ADDENDUM 4

ADDENDUM DATE: July 16th, 2019

PROJECT: Asheboro City Schools – HVAC Installation - Gymnasiums
Asheboro, NC 27203

T 919 781 6582
F 919 781 3979
4600 Lake Boone Trail
Suite 205
Raleigh, NC 27607
info@smithsinnett.com

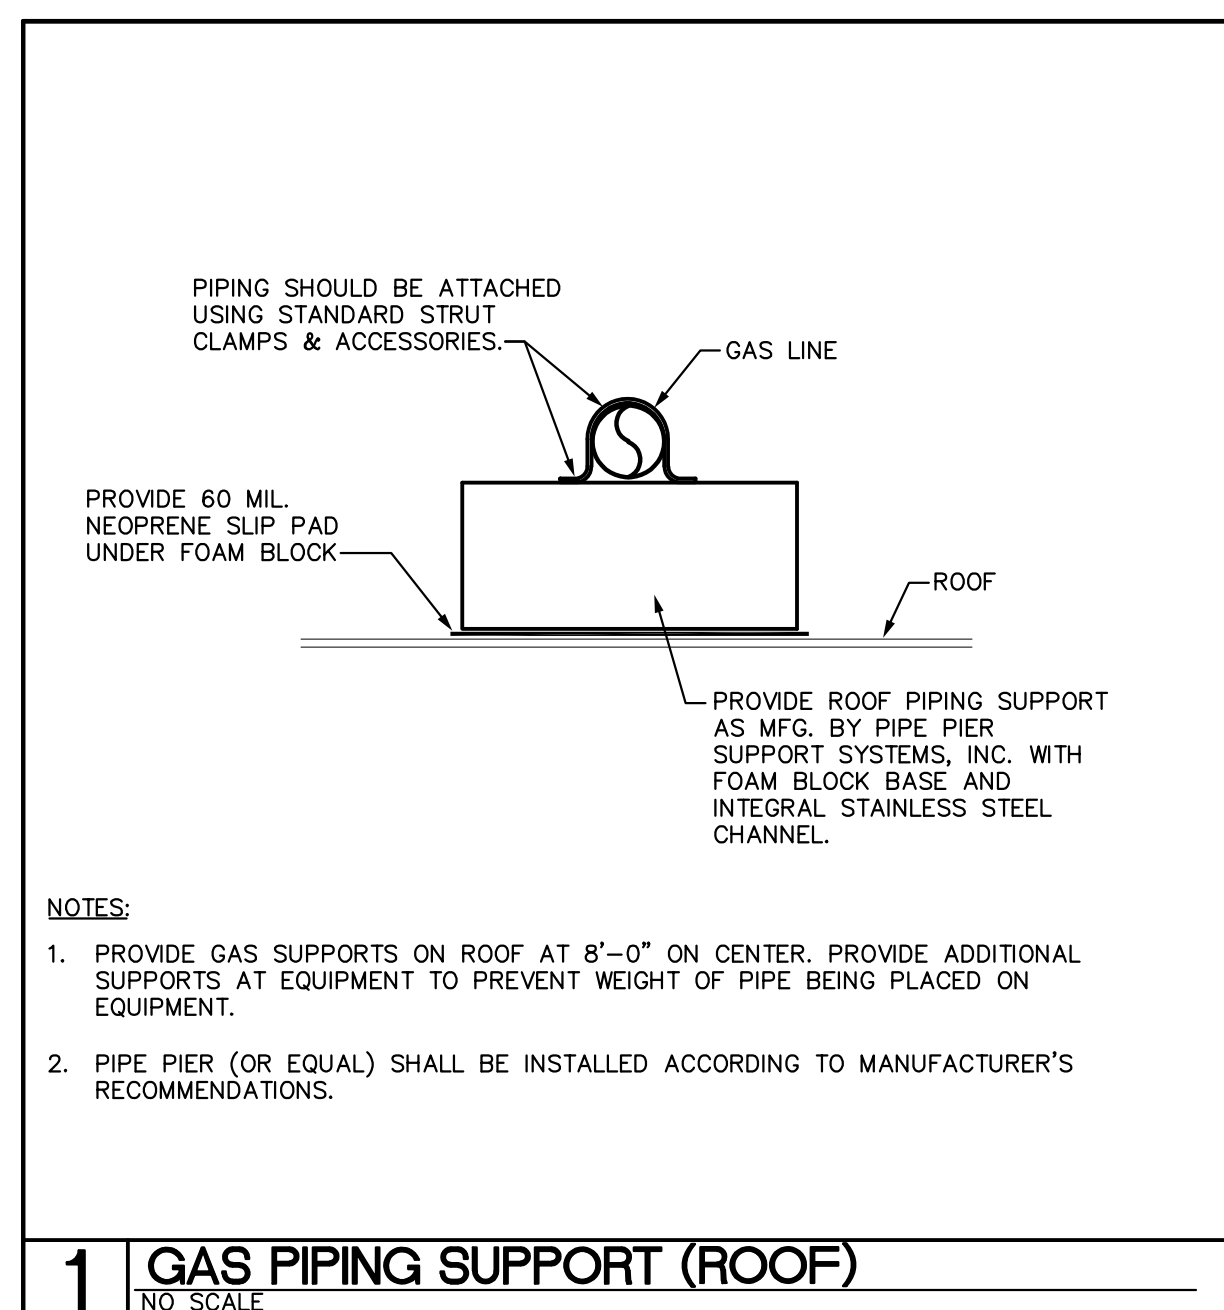
- Item 6 **REPLACE:** Sheet M0-02, M1-11A, M1-11B, and M1-11C. Revised sheet M0-02 provides information on ventilation calculations and outside air delivery amounts. Revised sheets M1-11A, M1-11B, and M1-11C provide information on added carbon monoxide detection and relocation of a plumbing vent.
